Company	Trenz Electronic GmbH
PCN Number	PCN-20190527
Title	TE0713-01-* to TE0713-02-* Hardware Revision Change
Subject	Hardware Revision Change
Issue Date	2019-05-27

This change affects all Trenz Electronic TE0713-01 SoMs: TE0713-01-*

#6 Full update LIB

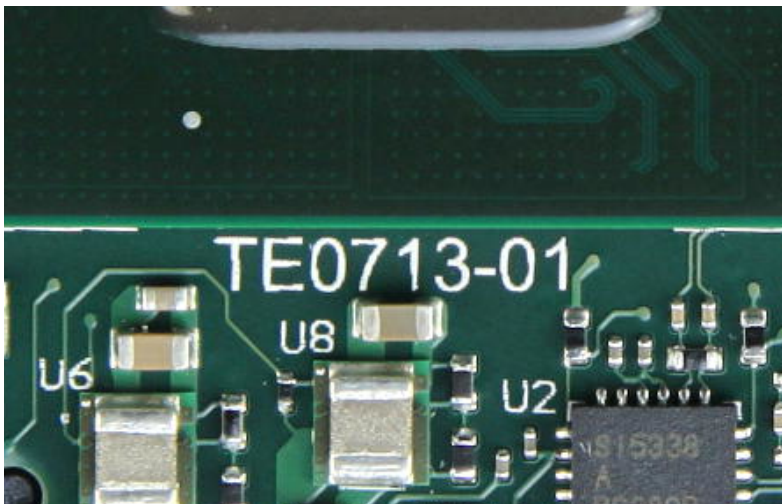
Type: PCB Change

Reason: Improve manufacturing yield

Impact: None
